# UNITED STATES PATENT AND TRADEMARK OFFICE

APPLICATION NO.	FILING DATE	FIRST NAMED INVENTOR	ATTORNEY DOCKET NO.	CONFIRMATION NO.
10/092,382	03/05/2002	Derek I. Finch	58937/131	8455

**Office Action Summary**

### **DETAILED ACTION**

Figure A: The modified figure corresponds to figure 4 with the flange shown.

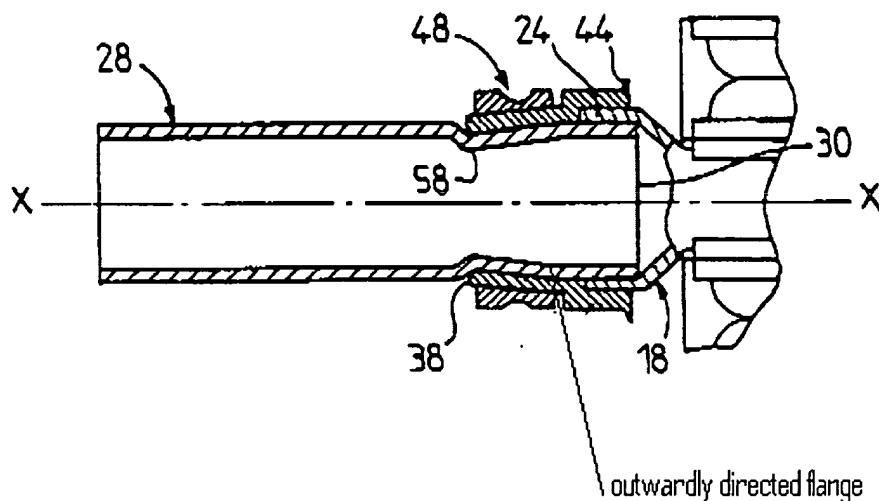
Claims 1,2,15 and 24 are rejected under 35 U.S.C. 102(b) as anticipated by or, in the alternative, under 35 U.S.C. 103(a) as obvious over Chevallier. Chevallier discloses (figures 1,4, figure A as bellow, and column 3, lines 50-63) a heat exchanger comprising a plurality of heat transfer plates (14) stacked together such that a plurality of fluid channels are provided there between the plates (12); at least one connecting grid comprises a pair of plates (20,22) separating the plurality of heat transfer plates into an upper group of heat transfer plate and a lower group of heat transfer plate (14), and at least one fluid connector (28) in fluid communication with a fluid channel via the connecting grid (18,20,22); the connector (28) comprising a tubular body having an outwardly directed flange formed integrally from a wall of the tubular body to sealingly connect the tubular body to a fluid channel (fluid flow chambers between the half plate (12)) between group plates (14) either on upper side or lower side of the connecting grid via an

opening (opening of the pipe connection 18) in one of the connecting grid plates. There are several openings in the connecting grid plates can be considered to read on the claimed opening. One is the opening of the pipe connection 18 as recited above. Alternatively, the openings that allow a fluid flowing from flow chambers between plates (20,22) to the other flow chambers of plates (14), is also considered to be the claimed opening. Though, Chevallier do not explicitly show the opening in the alternative case, it is inherently that an opening must exist in one of the plate (20,22) for the fluid flowing to the plates (14). For proof of evidences, the similar type of plate heat exchanger to Chevallier is cited hereby to explicitly show the opening in the connecting grids to allow fluid flowing to the other plates (See 5,358,034 or 5,390,732 with openings of 26 or 20 shown respectively). Furthermore, the outwardly directed flange is formed by deforming an end portion of the tubular body (See figure A). Chevalier further discloses (figure 4) that the fluid connector (28) extends within the pipe connection (18) which is formed by part of the pair of plates (20,22). Therefore, it is proper to conclude that the fluid connector extends between the pairs of plate. Chevallier further discloses (figure 1) the connector (28) provides an inlet/outlet connection on one side of the connecting grid externally of the heat exchanger and connected to both plates (20,22) of the connecting grid. As regarding claim 24, Chevallier does not disclose that the nominal diameter to wall thickness ratio of the tubular body is within 20 to 70. Applicant has not disclosed that having this typically range solves any stated problem, or is for any particular purpose or there is any criticality for selecting this range. Moreover, it appears that the fluid connector would perform equally well with the ratio that shown in Figure 4 of Chevallier. Accordingly, the use of this range is deemed to be a design

consideration which fails to patentably distinguish over the prior art of Chevallier. In re Aller, 105 USPQ 233.
